TEXAS DEPARTMENT OF INSURANCE

Proposed Change to Windstorm Building Requirements or Procedures in the Texas Windstorm Insurance Association Plan of Operation

International Building Code Limitations on the use of perforated shear walls.

Document IBC
Section 2305.3.8.2.1

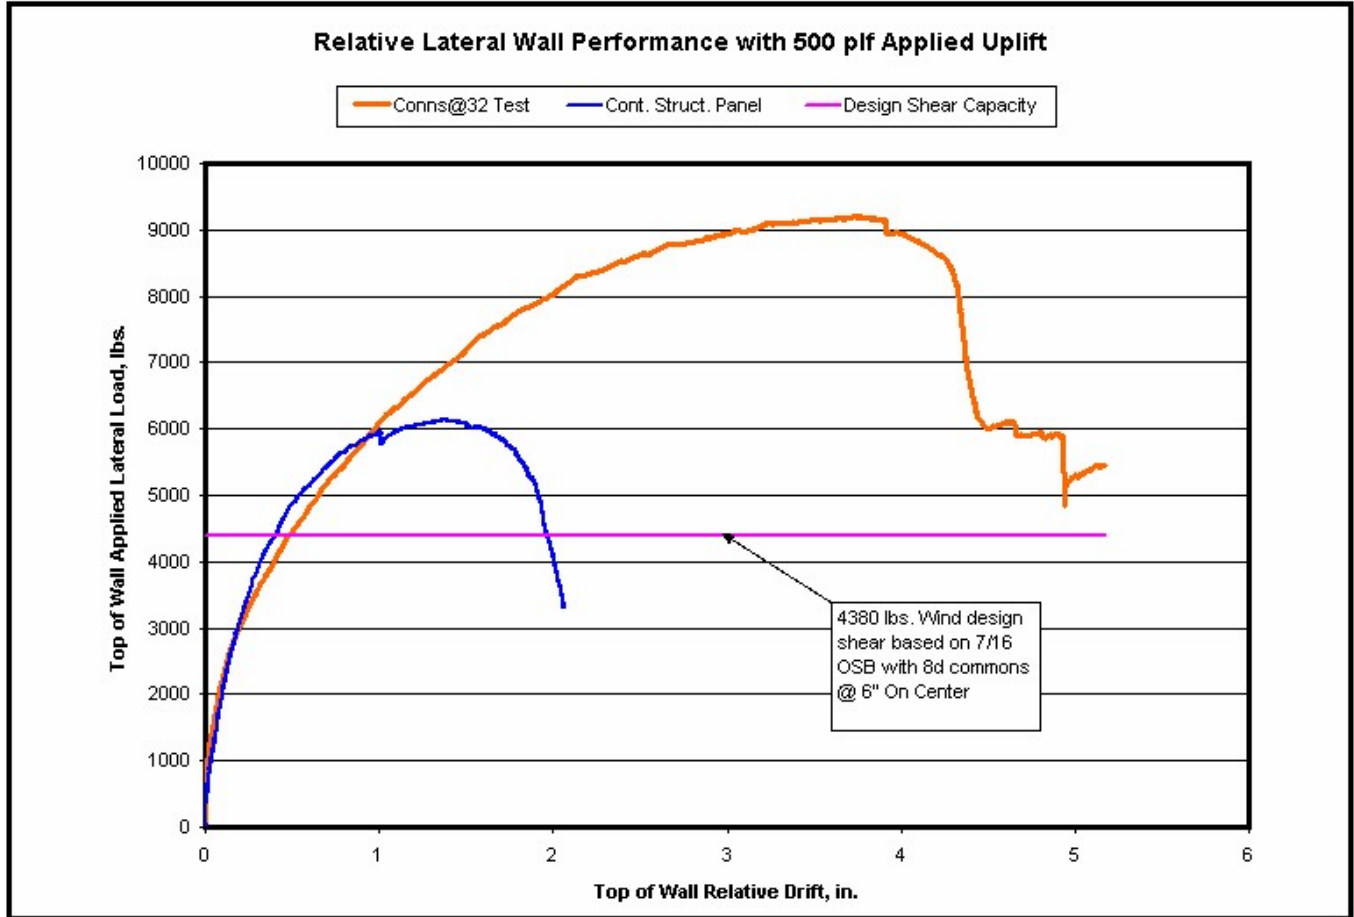
Simpson Strong-Tie has recently completed testing in our state-of-the-art full-scale test facility that conclusively shows that wood structural panel shear walls cannot be subjected to both wind uplift and shear forces and maintain the required safety factors. The failure is sudden splitting of the sill plate, even if large plate washers are installed.

The graph below shows the reduction in shear capacity of a shearwall that is designed for and subjected to combined uplift and shear simultaneously, compared to the same wall subjected to the same loads that uses connectors to resist the uplift.

6. Perforated shear wall height, h , shall not exceed 20 feet (6096 mm).
7. Perforated shear wall sheathing shall not be designed to resist wind uplift forces except for uplift due to overturning from lateral forces.
